LumiNode / LumiCore

RELEASE NOTES

VERSION 2.4.3

Figure 1

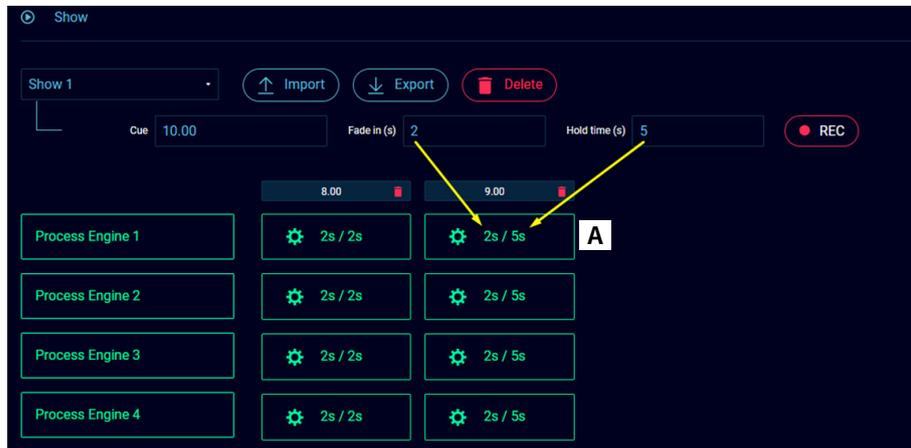
- Apart from a fade time, a cue now also stores a hold time. The hold time is used to hold the cue for a set amount of time and then automatically proceeds to the next cue in the list. If no hold time is set ("-") the cue will stay until a new GO trigger. The last cue in a list will return to the first cue automatically after passing of the hold time stored in that last cue [See figure 1: **A**].

Figure 2

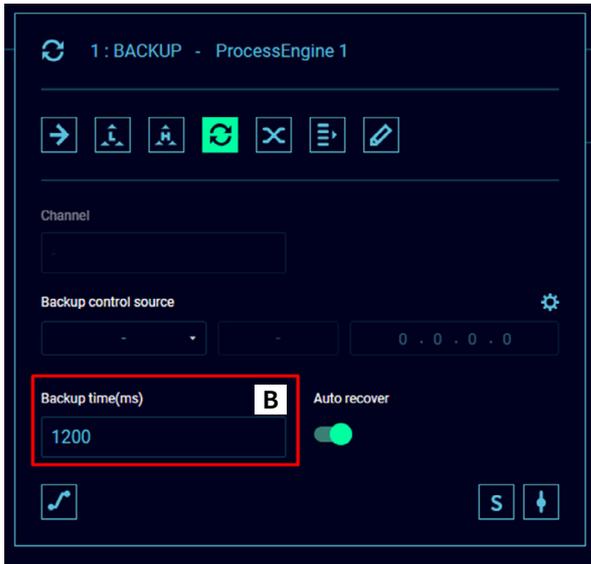
▪ The default backup time has been increased from 400ms to 1200ms to accommodate a wider range of applications out of the box. E.g., Some consoles fall back to only 1 FPS in case channel values don't change [See figure 2: **B**].

Figure 5

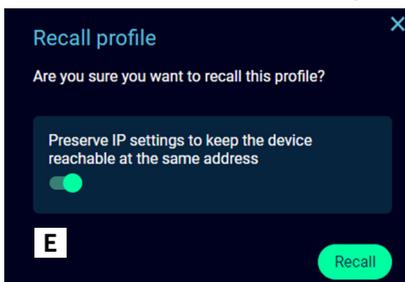
▪ A user prompt was added to confirm if IP settings need to be recalled at recalling a profile [See figure 5: **E**].

Figure 6

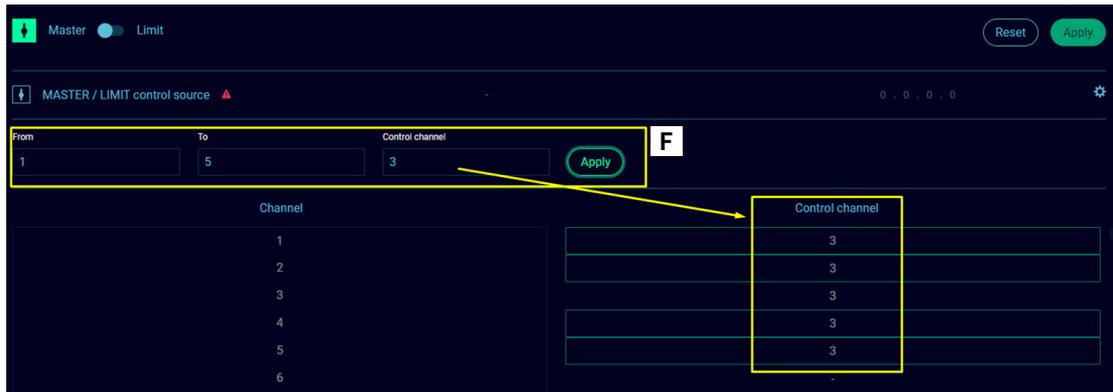
- Workflow is improved for the control channel selection for process engines, now users can enter multiple channels in one go instead of entering each control channel individually [See figure 6: **F**].

Figure 7

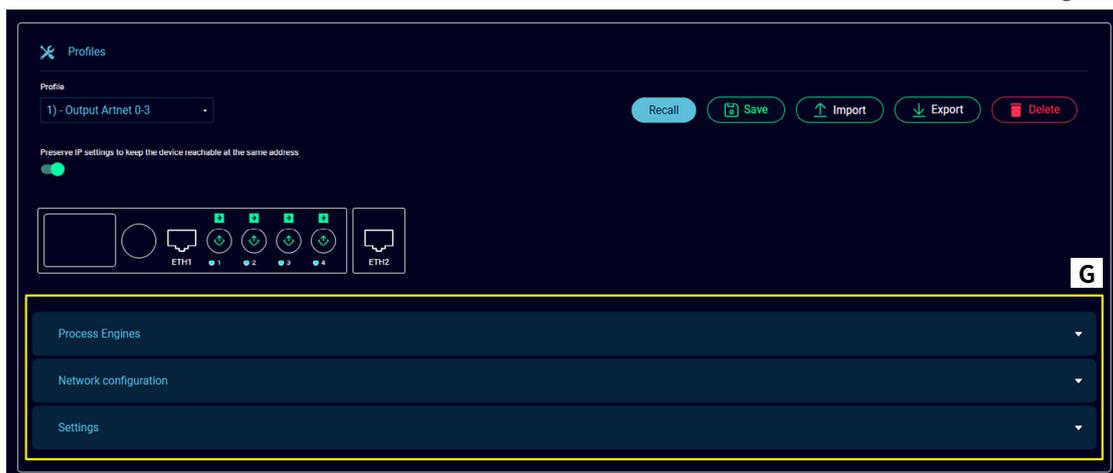
- In the profile preview, expandable menus have been created so users of models with many process engines (i.e. LumiCore) won't have to scroll as often to see all page items [See figure 7: **G**].
